**Addendum 82: Regulation No. 83**

**Revision 3 - Amendment 4**

Supplement 9 to the 05 series of amendments: Date of entry into force: 17 March 2010

UNIFORM PROVISIONS CONCERNING THE APPROVAL OF VEHICLES WITH REGARD TO THE EMISSION OF POLLUTANTS ACCORDING TO ENGINE FUEL REQUIREMENTS

Figure 8/1: Parameters measured during emissions test during and between cycles where regeneration occurs (schematic example, the emissions during 'D' may increase or decrease)

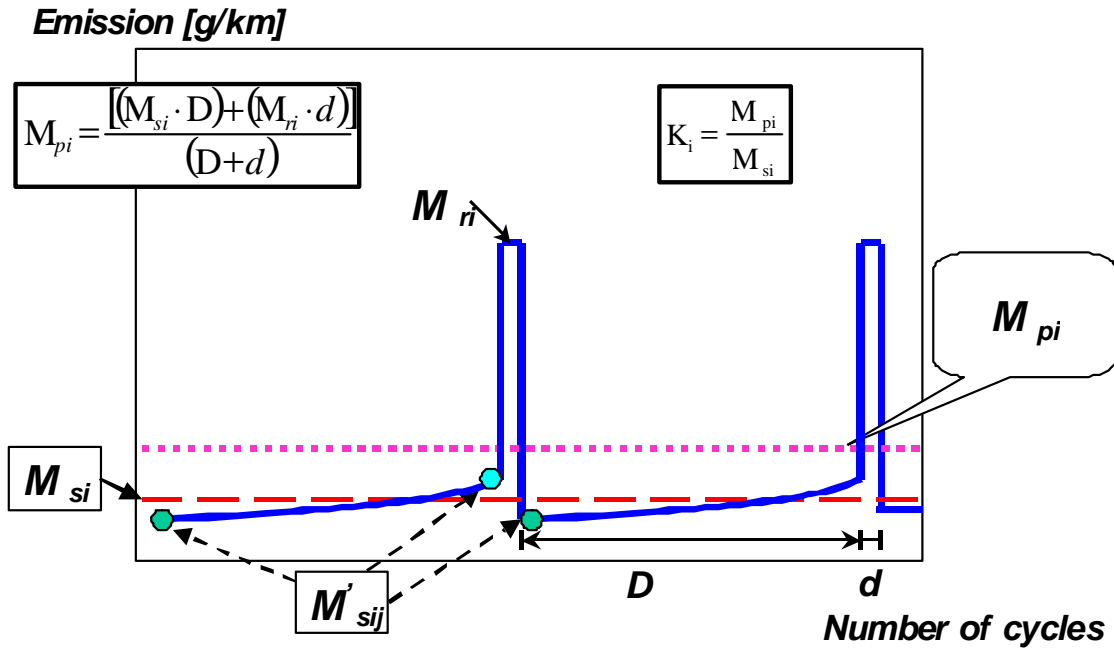
For an illustration of measurement parameters see Figure 8/1.

Figure 8/2: Parameters measured during emissions test during and between cycles where regeneration occurs (schematic example)

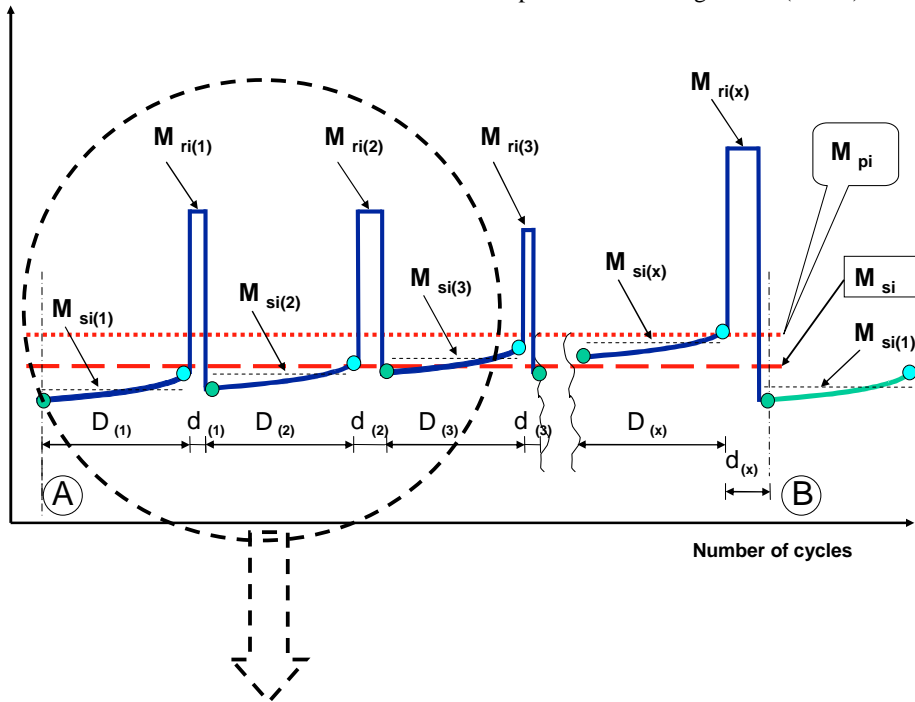
For an illustration of measurement parameters see Figure 8/2 (below)

The calculation of the factor ( $K_i$ ) for multiple periodic regenerating systems is only possible after a certain number of regeneration phases for each system. After performing the complete procedure (A to B, see Figure 8/2), the original starting conditions A should be reached again.

Figure 8/3: Parameters measured during emissions test during and between cycles where regeneration occurs (schematic example)

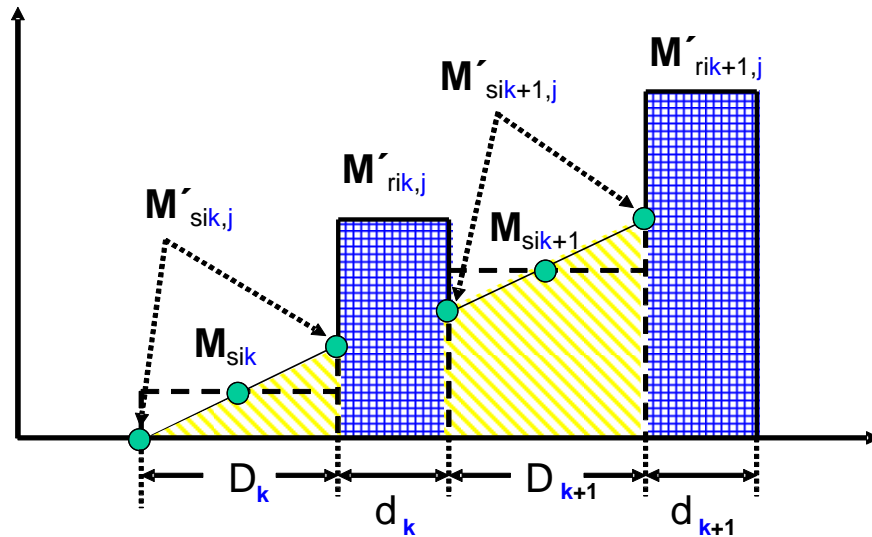
For more details of the schematic process see Figure 8/3

For application of a simple and realistic case, the following description gives a detailed explanation of the schematic example shown in Figure 8/3 above:

1. "DPF": regenerative, equidistant events, similar emissions ( $\pm 15$  per cent) from event to event

2. "DeNOx": the desulphurisation ( $\text{SO}_2$  removal) event is initiated before an influence of sulphur on emissions is detectable ( $\pm 15$  per cent of measured emissions) and in this example for exothermic reason together with the last DPF regeneration event performed.

3. Complete system (DPF + DeNOx):
